SUBJECT: CRYSTAL SPRINGS DRAINAGE IMPROVEMENTS

J. B. COXWELL CONTRACTING, INC.
CRYSTAL SPRINGS STORMWATER IMPROVEMENTS
CONTRACT 6533-55

Change Order No. Two (2) Date November 21, 2017

Description of Project Crystal Springs Stormwater Improvement Project

C-109

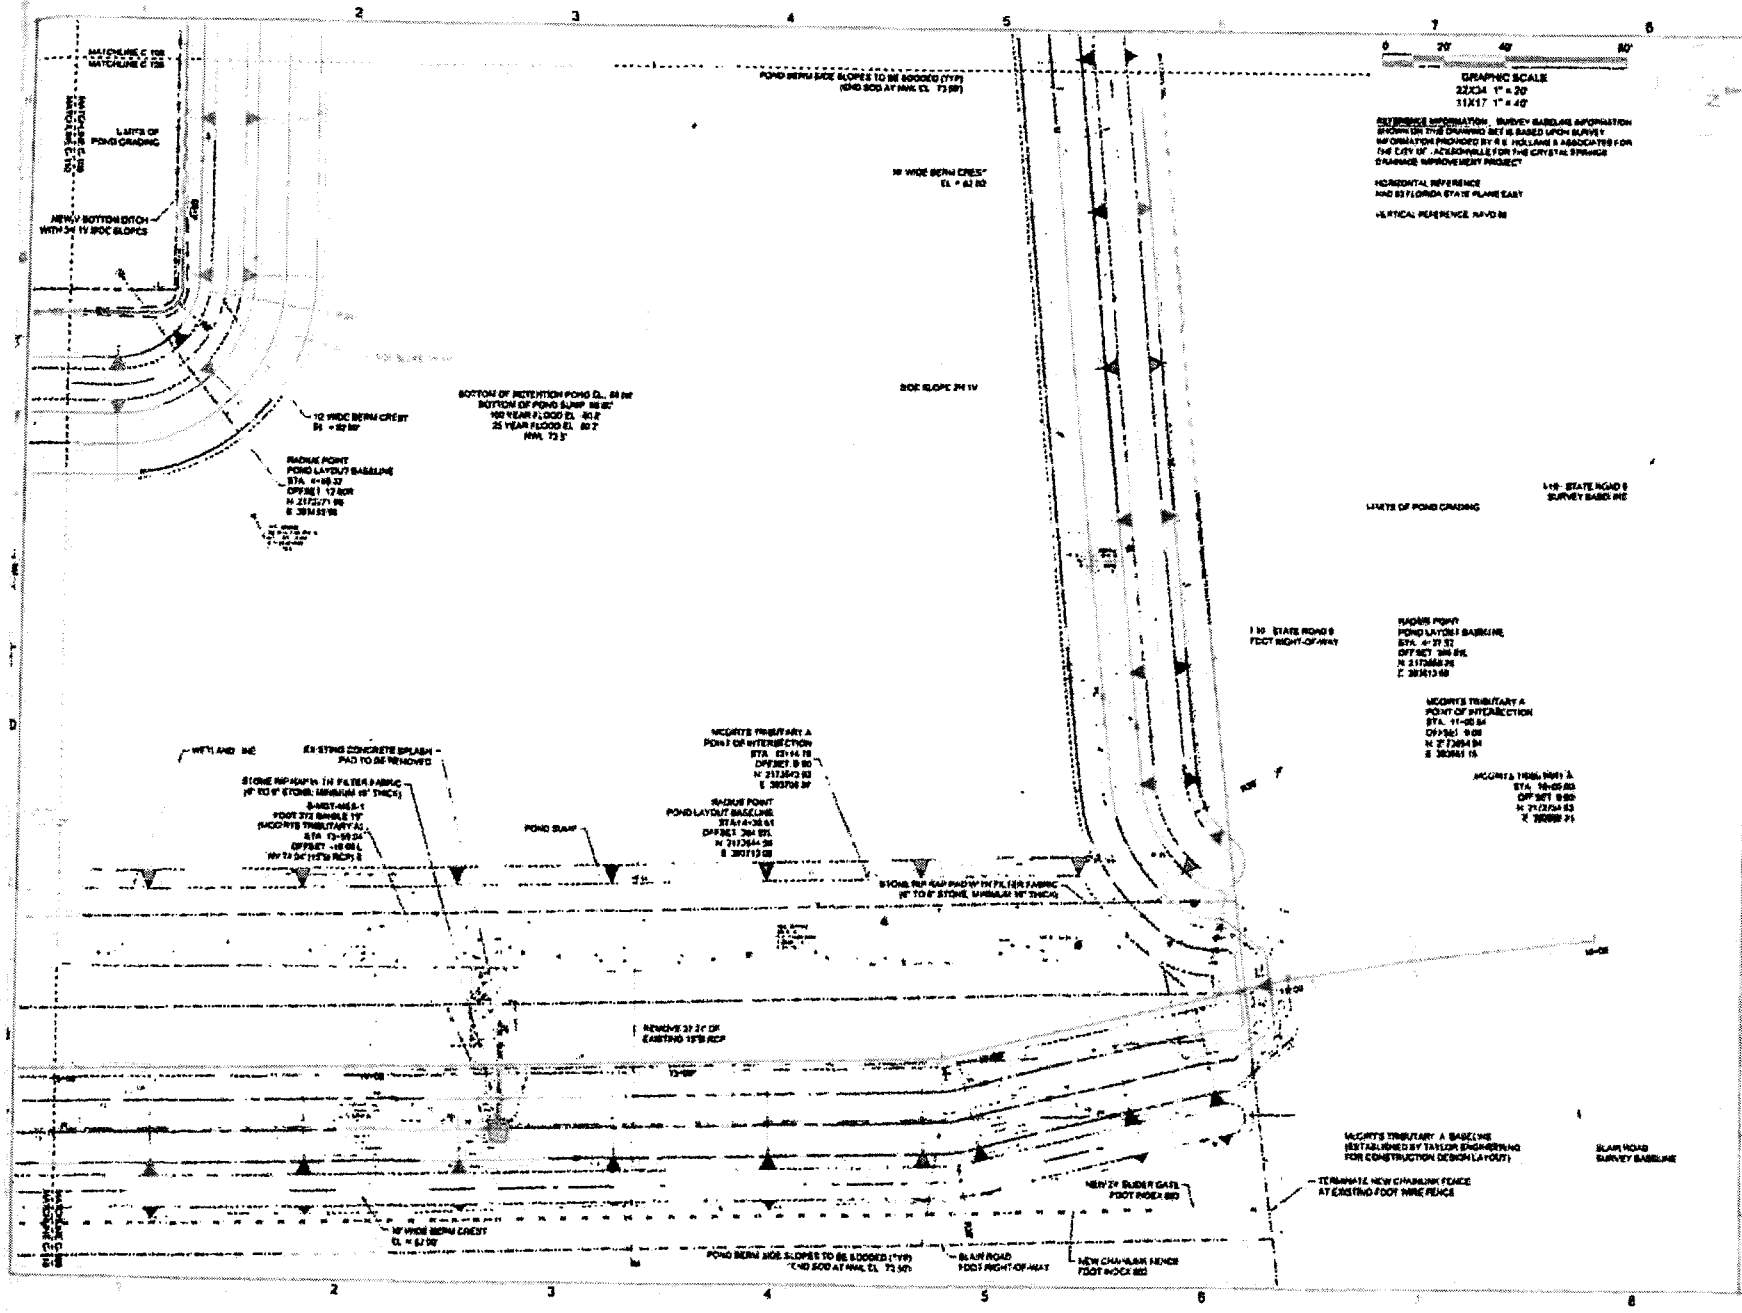
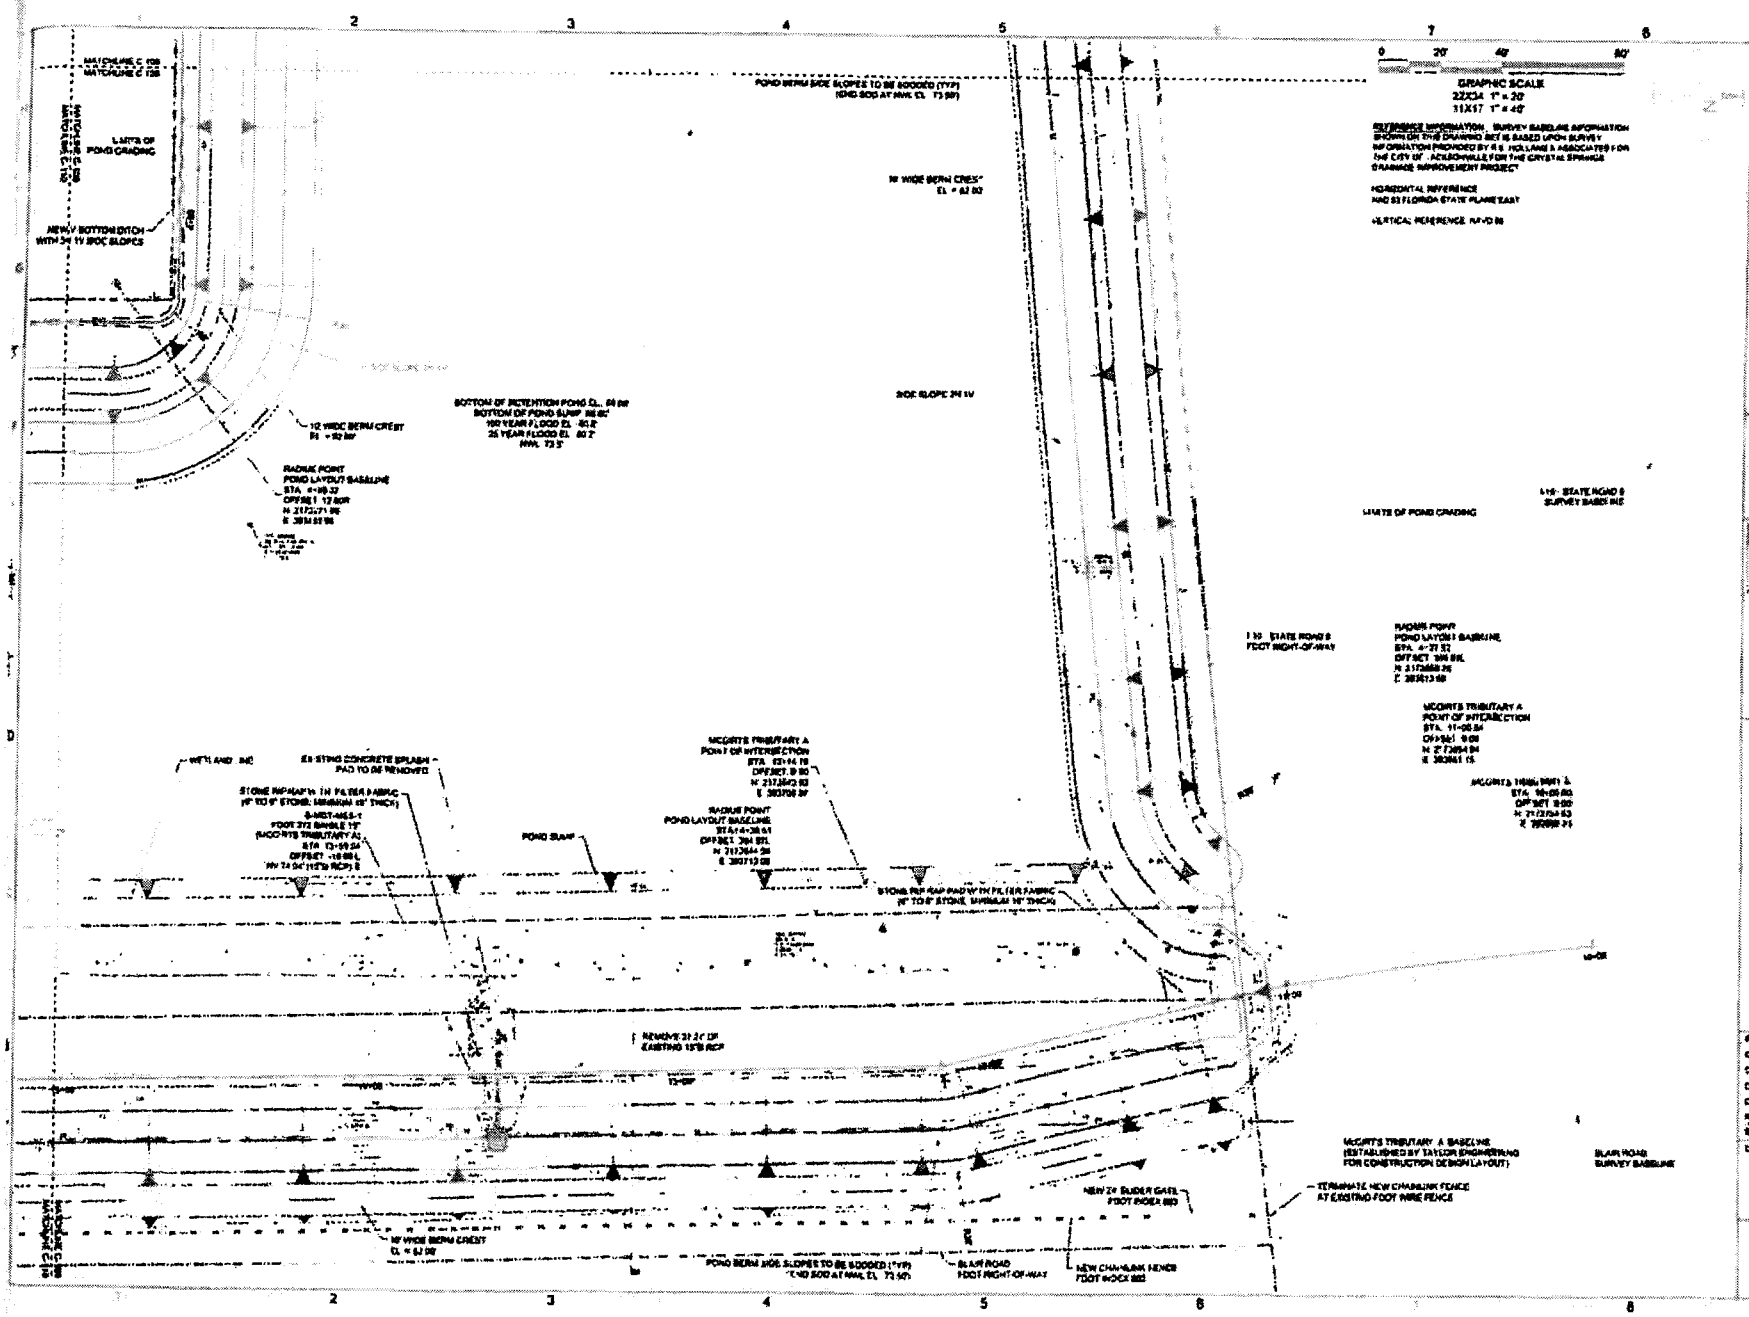
Nine trees were identified as being undermined and unsafe due to excavation identified in the plans along the western bank of McGirts Creek adjacent to the property of homeowner Mr. Cassidy. It was determined these trees should be removed because they could potentially damage the homeowners property or impede drainage flow of the creek if they were to fall.

DRAWING TITLE
JOES ROAD INTERSECTION SITE PLAN

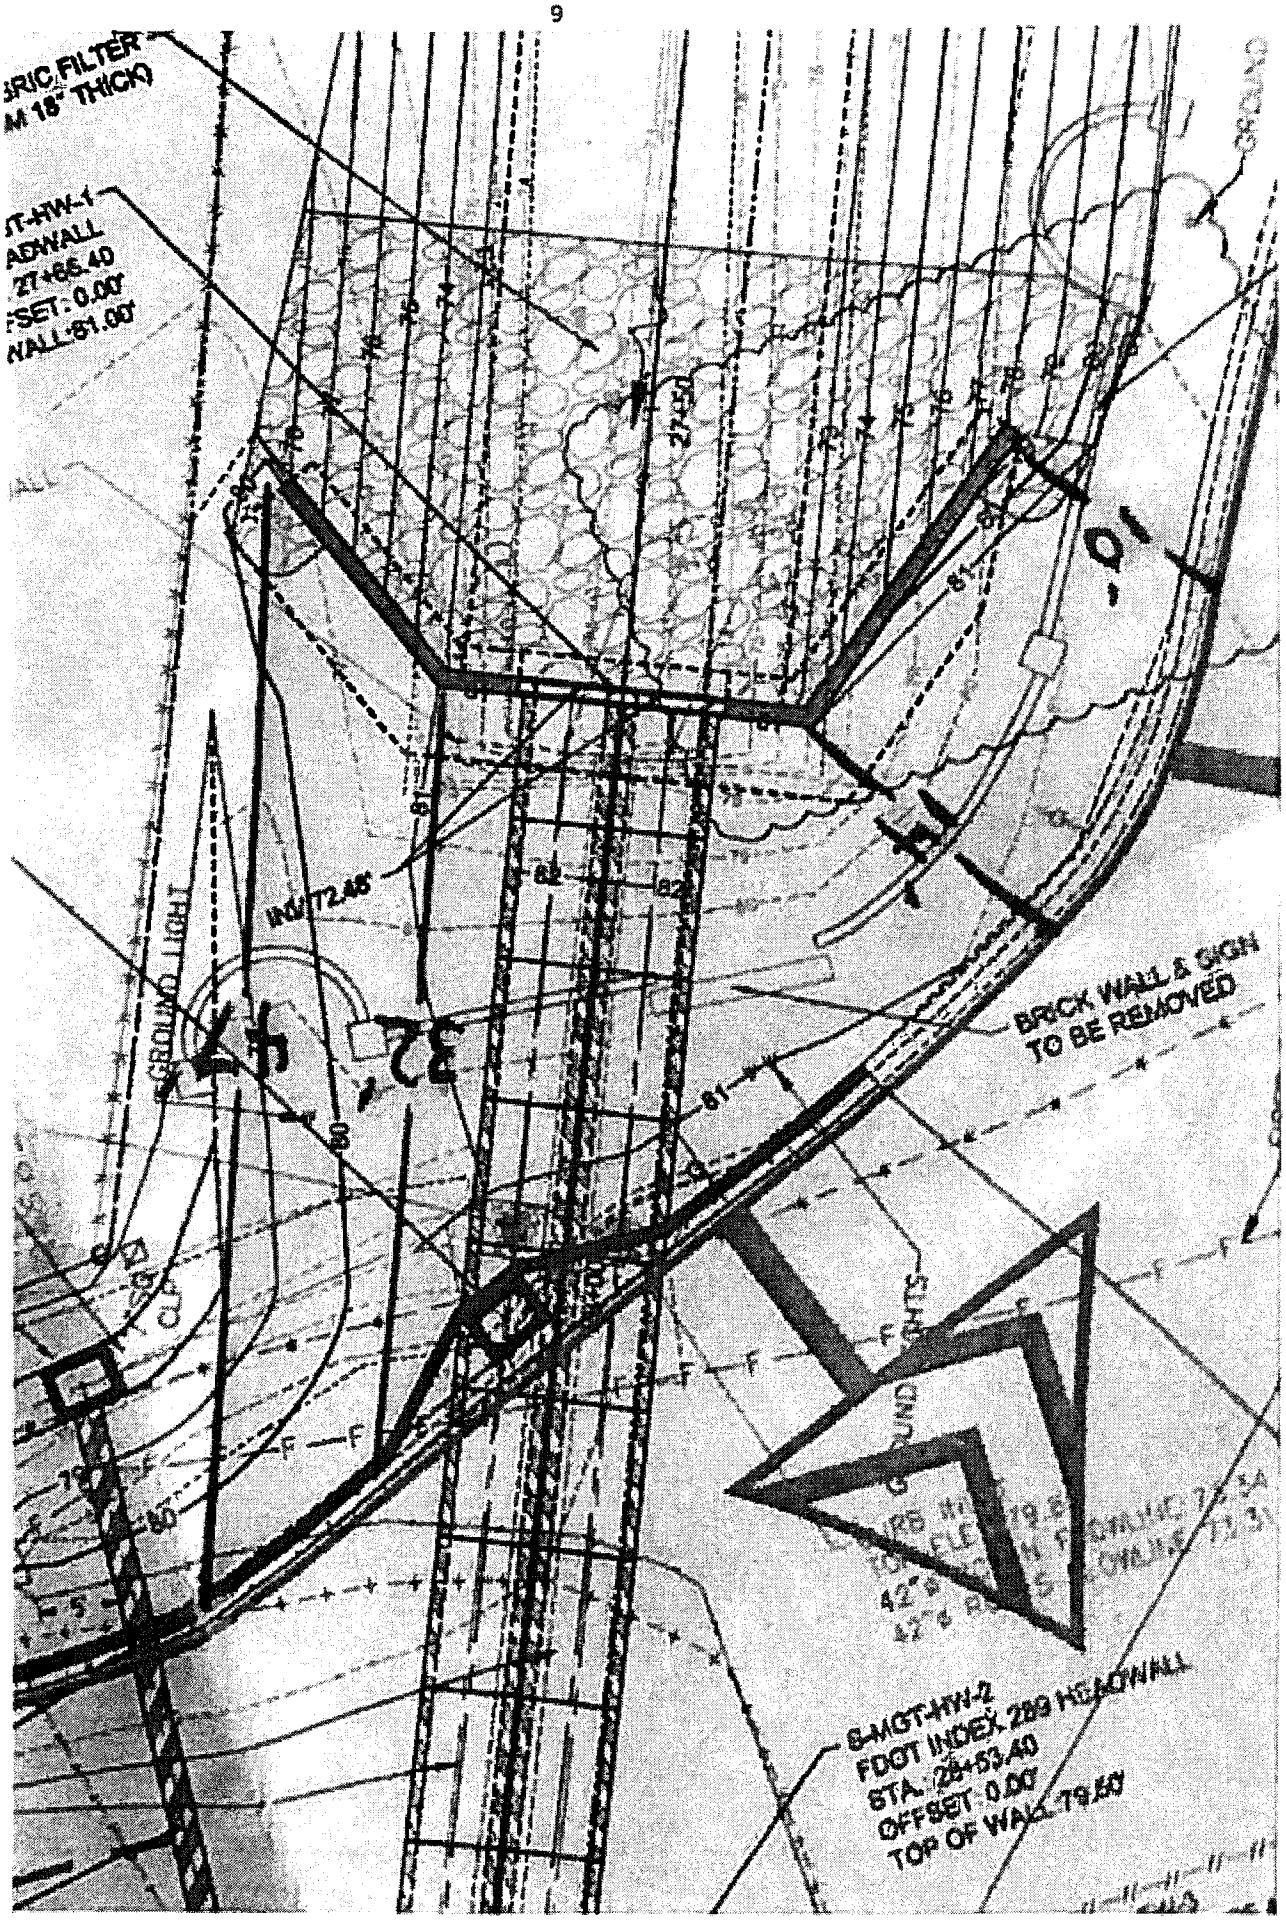
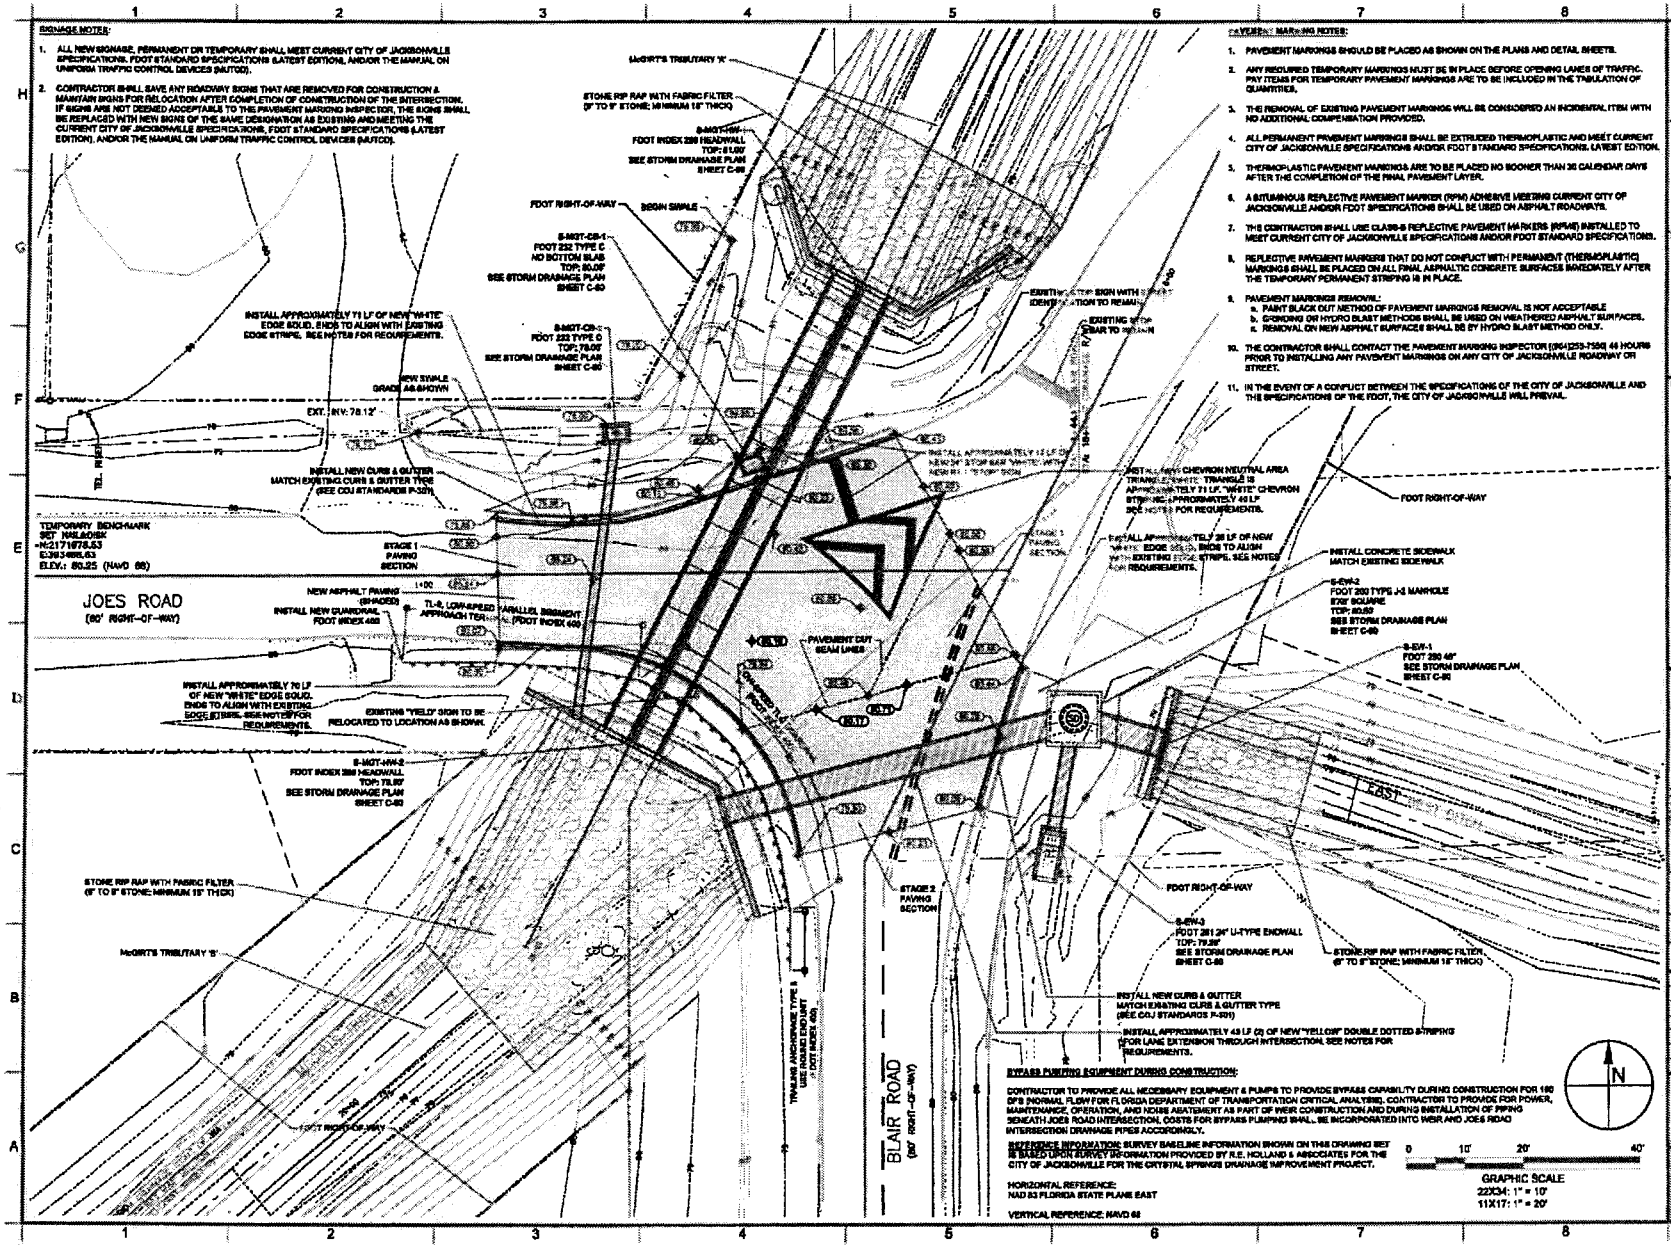
According to the project plans on sheet C-79, there is a guardrail shown between the southern headwall and roadway at the Joes and Blair Roads intersection. The guardrail specified on the plan sheet is approximately 100 linear feet of FDOT Index 400 guardrail. According to the City of Jacksonville's pay application in the final bid proposal package and the pay items listed in Addendum No.5, there is no pay item associated with or for the purchase and installation of this guardrail. Further, this guardrail does not appear to be addressed within the project specifications. JBCCI requests clarification on whether the COJ wants this section of guardrail to be installed as part of this project and if so, please provide specifications on this section of guardrail such that quotes can be obtained. Please advise as soon as possible such that this work can be added to the existing scope of work for the intersection.

Response: Guardrail on both the North and South side of the intersection should be constructed as shown on sheet C-79. See attached sketch and revised plan sheet for cross-slope, offset, misc. asphalt details and end treatments. FDOT Specification 536 and Index 400 should be followed. Post in conflict with the box-culvert and 48" concrete pipe should be modified and installed per the encased guardrail post detail included in FDOT index 400.
